UWMC-Northwest Major Institution Master Plan (MIMP)

Development Advisory Committee Meeting #10
December 4, 2023

1. Campus Access Points

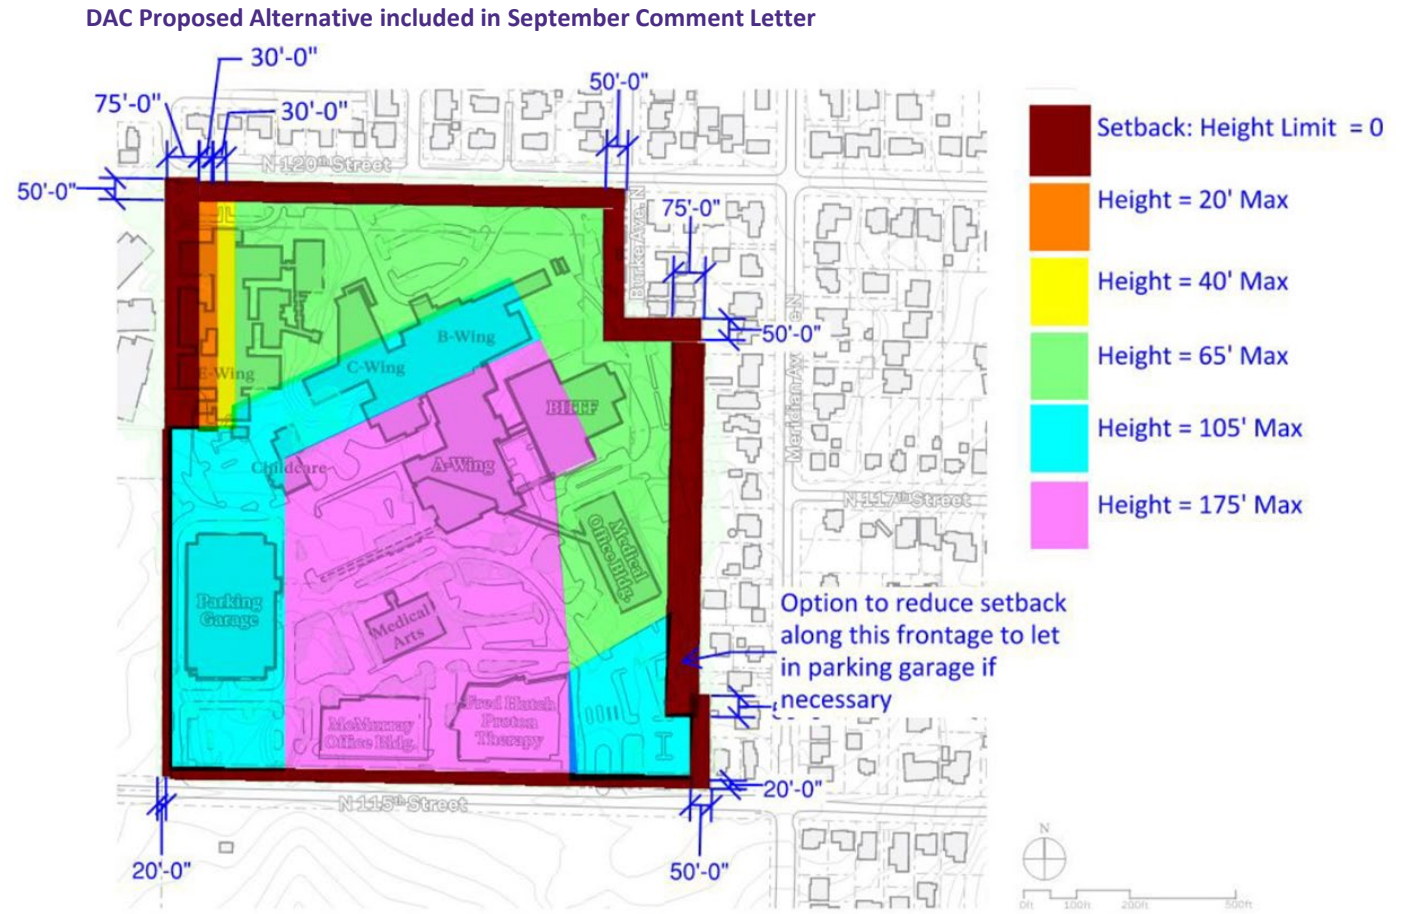
- Strong preference from DAC for third campus entry to be placed along N. 115th rather than N. 120th Street.

- Recommends N. 115th Street for the third access point.
- N. 120th Street still included as a studied option in the Draft EIS.

Testing DAC Alternative Height & Setbacks

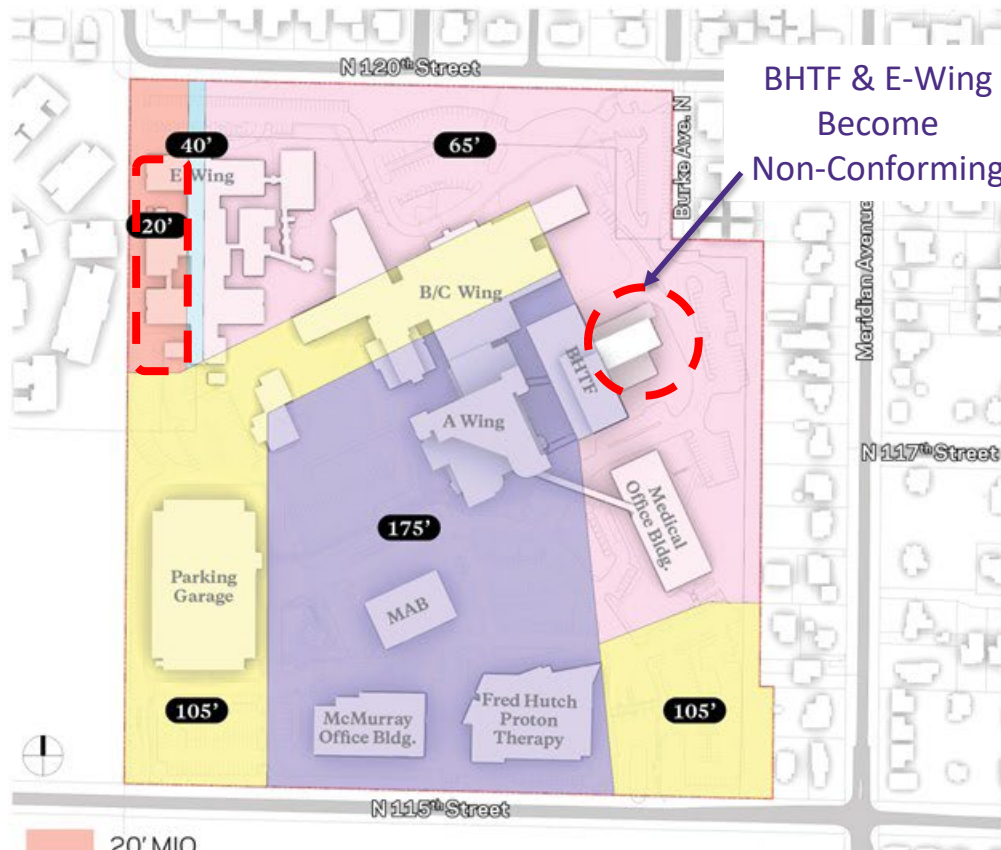
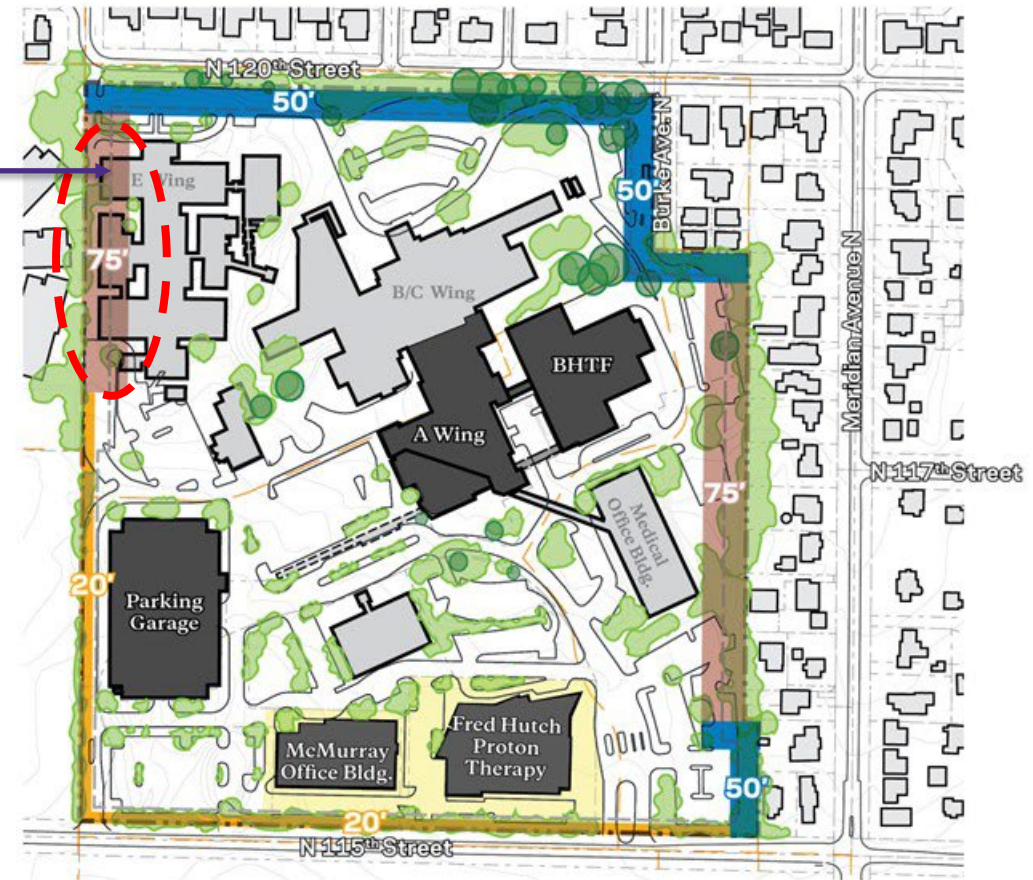
- Extended 105' zone over B/C-Wings to step down height at center of site
- Stopped northern extents of 105' zone (near garage) to align with closest Stendall Place home, to potentially accommodate garage expansion to north
- Centered 175' height on site and towards N 115th St. (acknowledged some non-conforming existing buildings)
- Added 105' zone to SE corner as one of the places they would like to see a parking garage
- Stepped down heights at NW corner because it's closest to "single story" residential (2-story)
- Added 75' setback on east and west edges in interest of equity
- Reduced to 50' setback at SE corner to make [garage] development there possible

Alternative #3 NEW: Heights

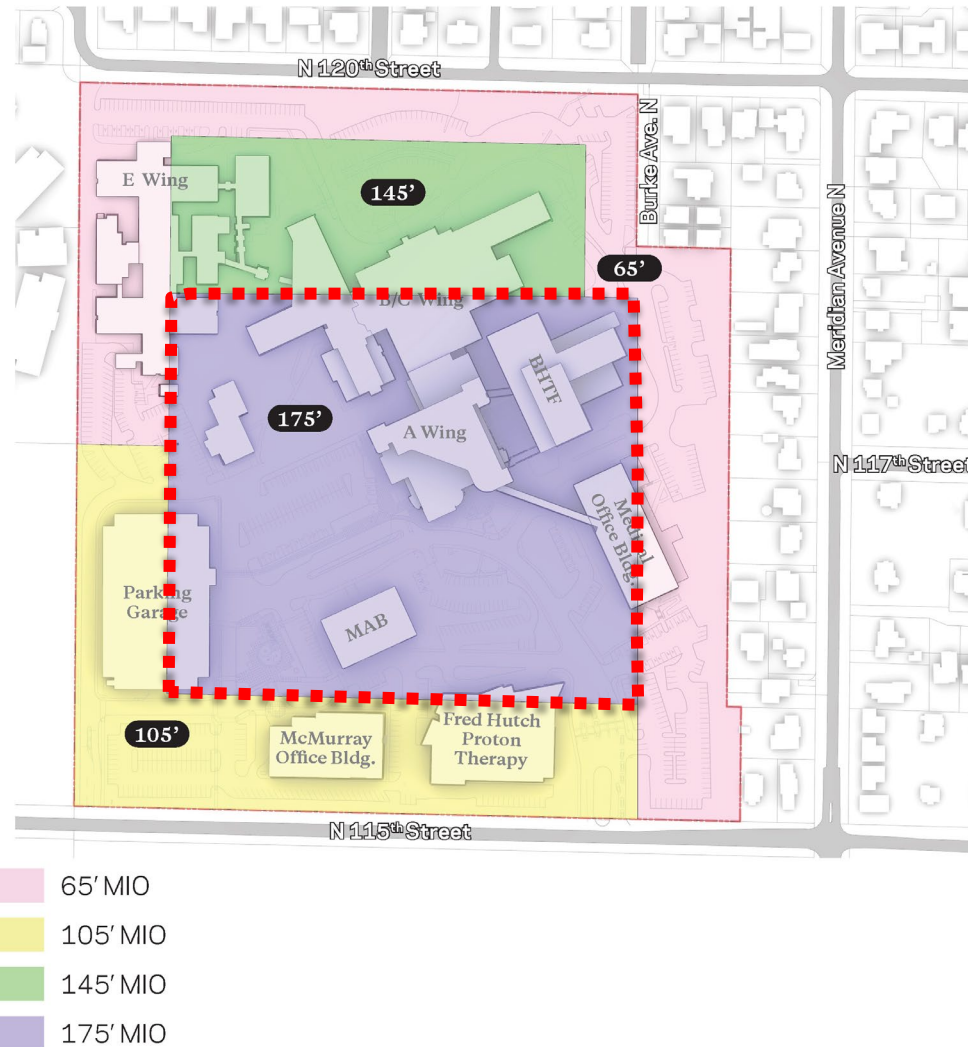
- Concentrate height to the center of campus, near A-Wing and/or toward N. 115th Street.
- UWMC recommends highest height at only center of campus.

Alternative #3 NEW: Heights

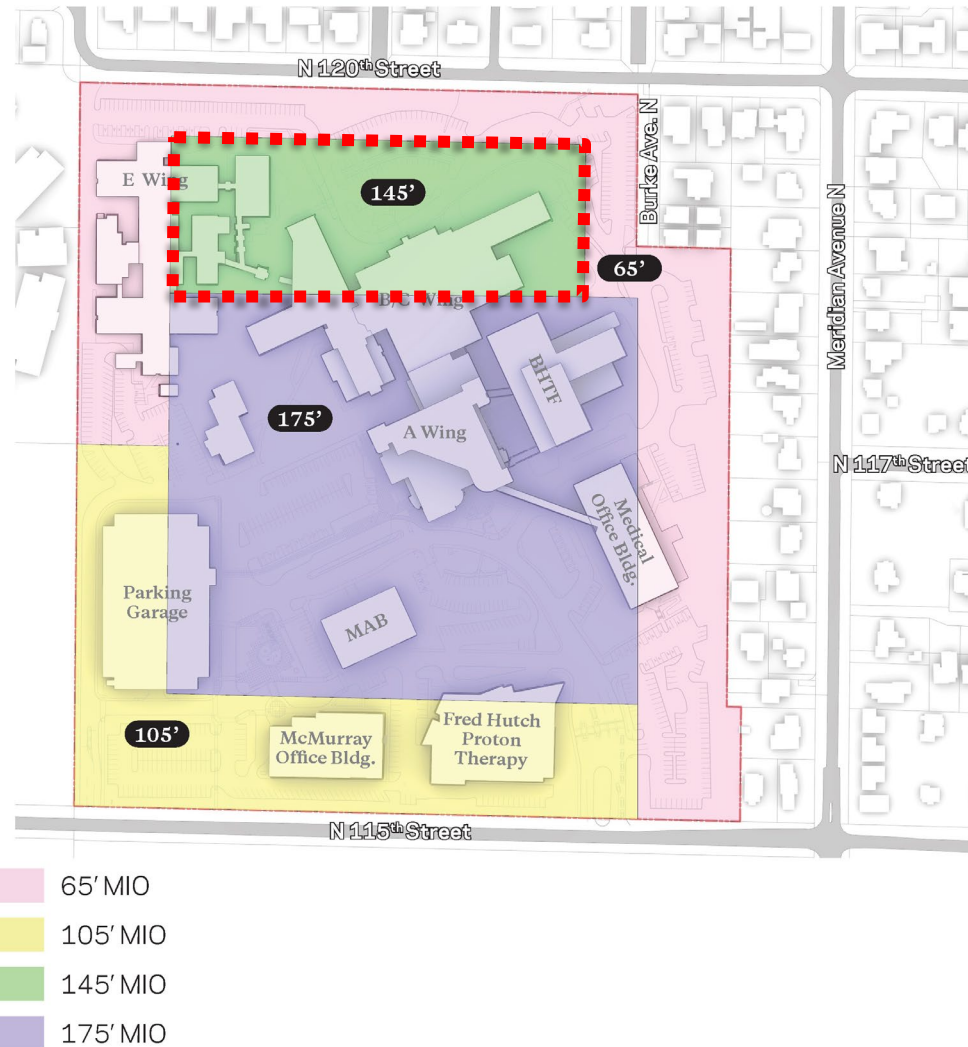
- Desire for lower height on north third of campus.
- New height overlay proposed, reducing height to 145' (160' MIO conditioned down to 145').
- Long-term hospital expansion (phases 2 or 3 or later) will step down to reduce height as much as possible.

Alternative #3 NEW: Heights

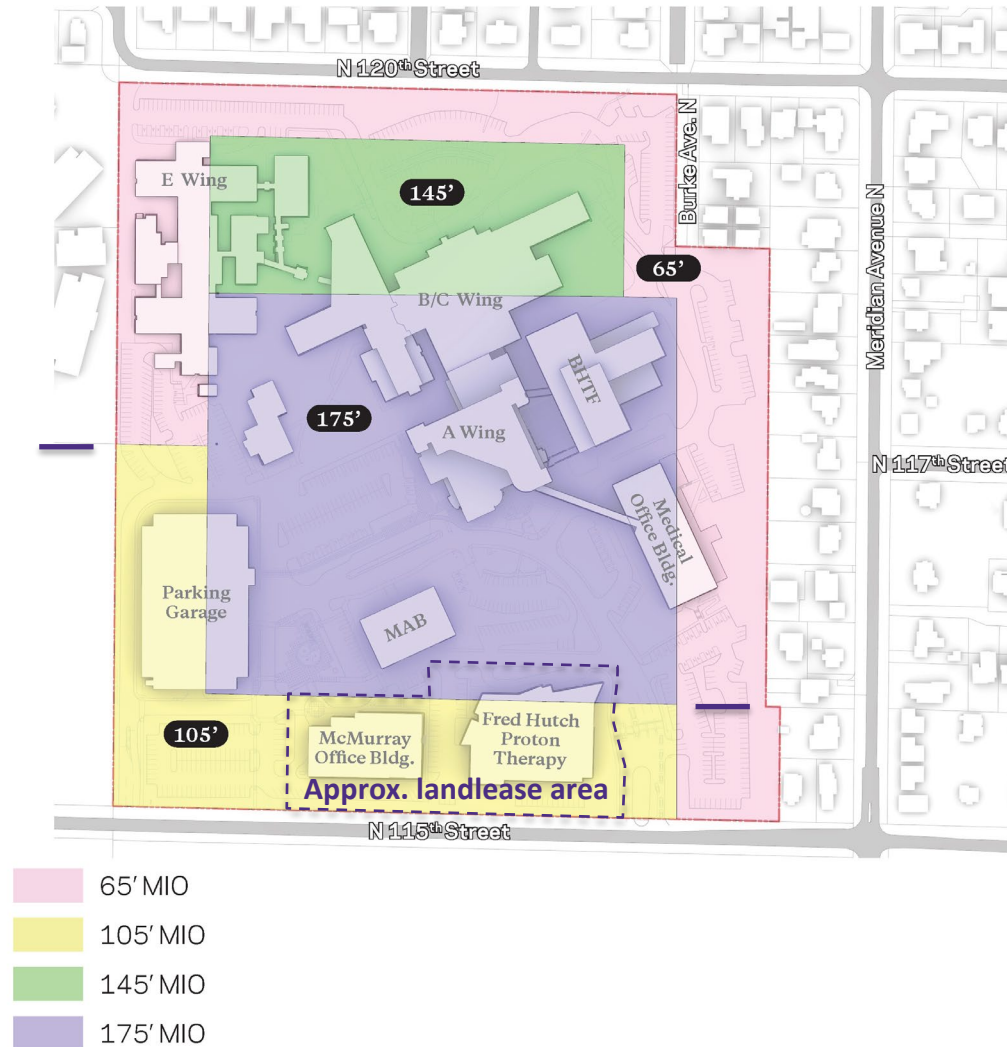
- DAC alternative and reasoning allowed greater height (175') along N. 115th Street
- No comments were concerned with height in this location.
- Campus landleases however preclude any UWMC development.
- 105' height overlay aligns with property line "notch" and adjacent parcel lines.

Alternative #3 NEW: Heights

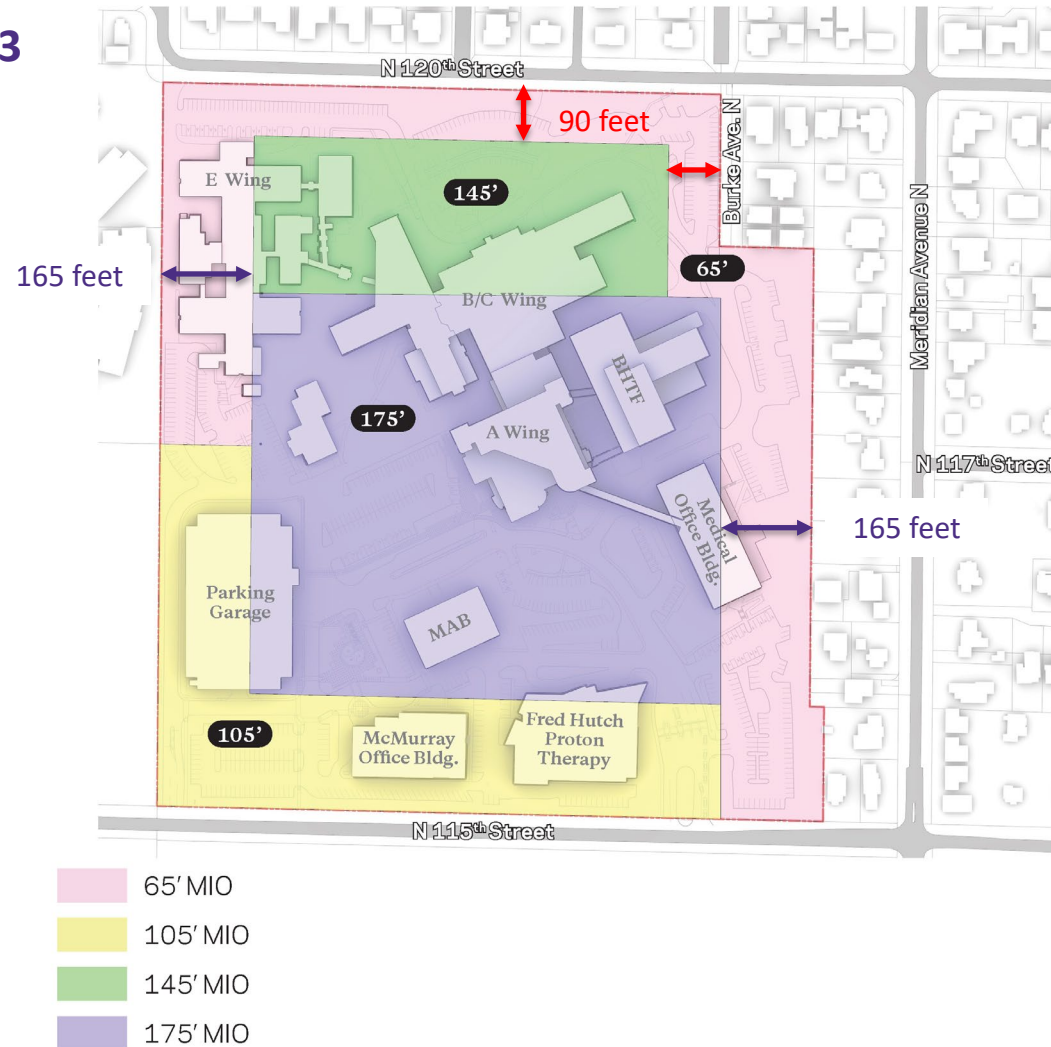
- DAC alternative reduced heights to more significant limitations than the existing MIMP and made E-Wing and part of BHTF non-conforming.
- Proposing 65' height overlay in consistent widths adjacent to ROWs (90 ft.) and residential neighbors (165 ft.).
- Height overlay near Stendall Place increased in width to 165 ft. wide; same width used for 105' MIO, less height than analyzed in Alternative 1.

Alternative #3 NEW: Setbacks

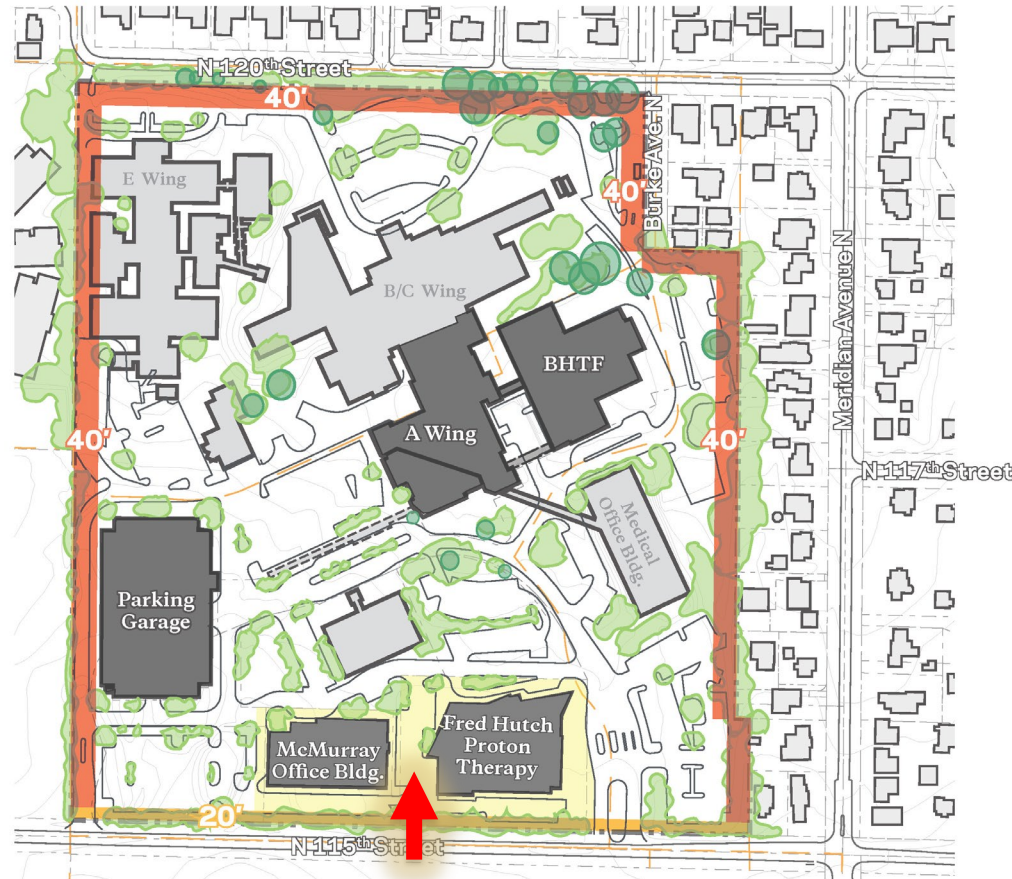
- DAC alternative and consistent public comment supported smaller setback near N. 115th Street.
- UWMC agrees with 20' setback on N. 115th Street.
- UWMC intends to maintain healthy, existing trees along N. 115th Street as much as possible.
- Proposed setback is same as what was studied in Alternative 2.

Alternative #3 NEW: Setbacks

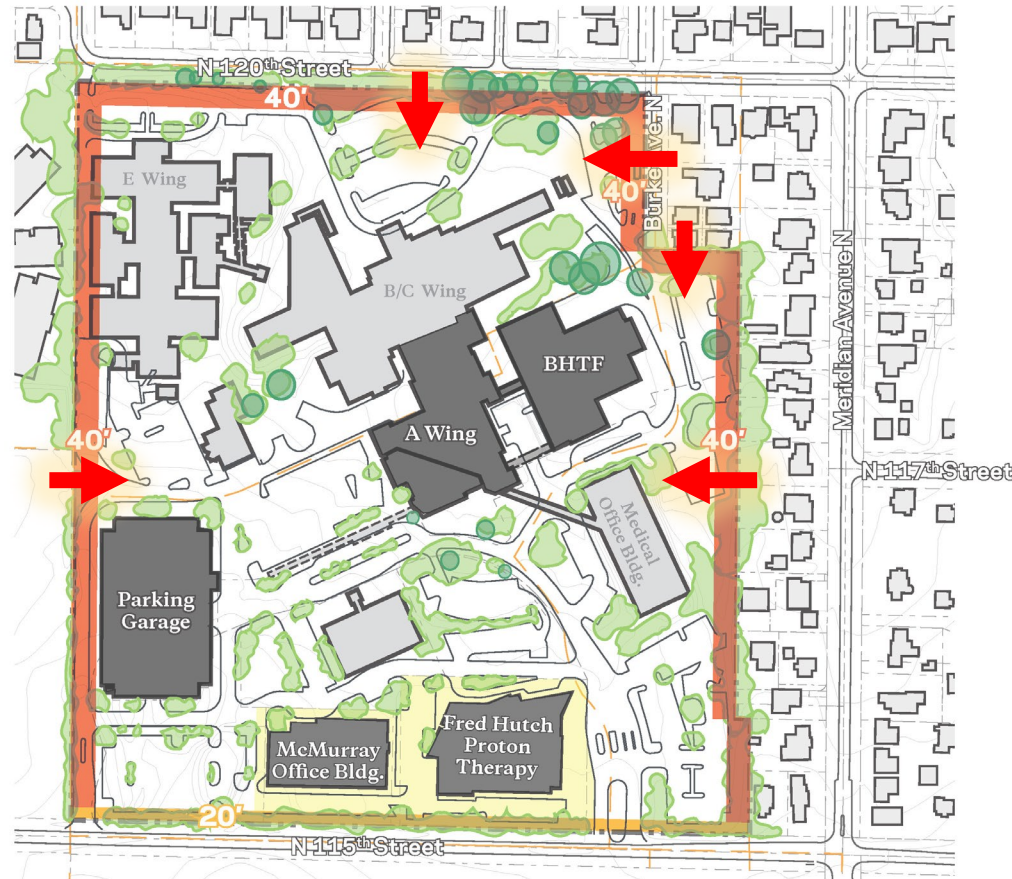
- DAC alternative increased setbacks to more significant limitations on abutting edges than the existing MIMP and made E-Wing non-conforming.
- Consistent public comments identified 40-50' as appropriate for north and residential edges.
- UWMC proposes 40' setback on majority of campus edges to be consistent and equitable with all residential neighbors.
- Proposed setbacks are same or greater than those studied in Alternatives 1 and 2.
